Comments on Docket No. FHWA-2020-0001 National Standards for Traffic Control Devices; the *Manual on Uniform Traffic Control Devices for Streets and Highways*; Revision

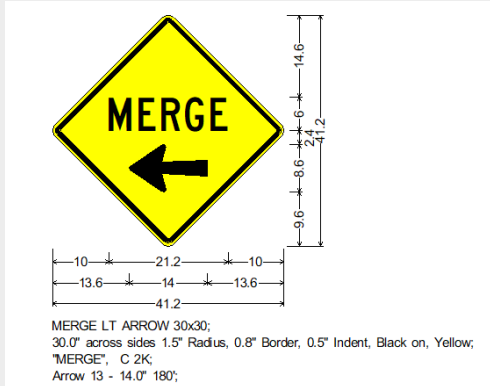
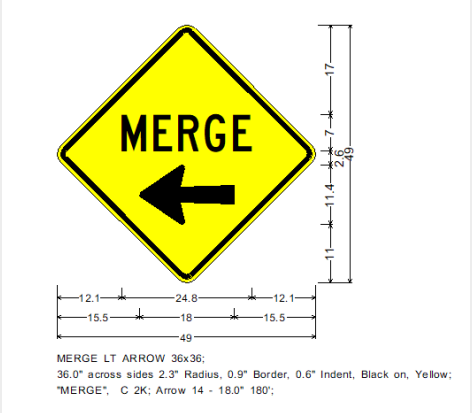
Reference Document	Page	Proposed Section Number	Line Number Start	Line Number End	Agree w/ concept; suggested rewording in Comments	Disagree with concept	Comment								
Text-Mark-up	371	3C.05	18	19		Yes	<p>Vehicles approaching a single lane roundabout are often looking for the fastest path. By placing two full and one half of a double-paired crosswalk (as shown in the photos below), crosswalk marking may be installed to avoid the wheel path.</p> <p>To help minimize crosswalk marking wear and increase crosswalk marking longevity at roundabout approaches, the MCUTCD is recommending removal of the sentence in lines 18-19 (page 371, Text-Mark up): "For the double-paired crosswalk design (see Section 3C.08), a coupling set of two longitudinal bars shall be considered to be one individual longitudinal element".</p>

<table><tr> <td data-bbox="1162 580 1961 620">Before (showing partial wear of the longitudinal bars):</td> <td data-bbox="1970 580 2728 620">After:</td> </tr><tr> <td data-bbox="1162 1211 1961 1251">Before (these two had worn off completely):</td> <td data-bbox="1970 1211 2728 1251">After (this one shows the tire track glare pretty well, even away from the crosswalk):</td> </tr></table>
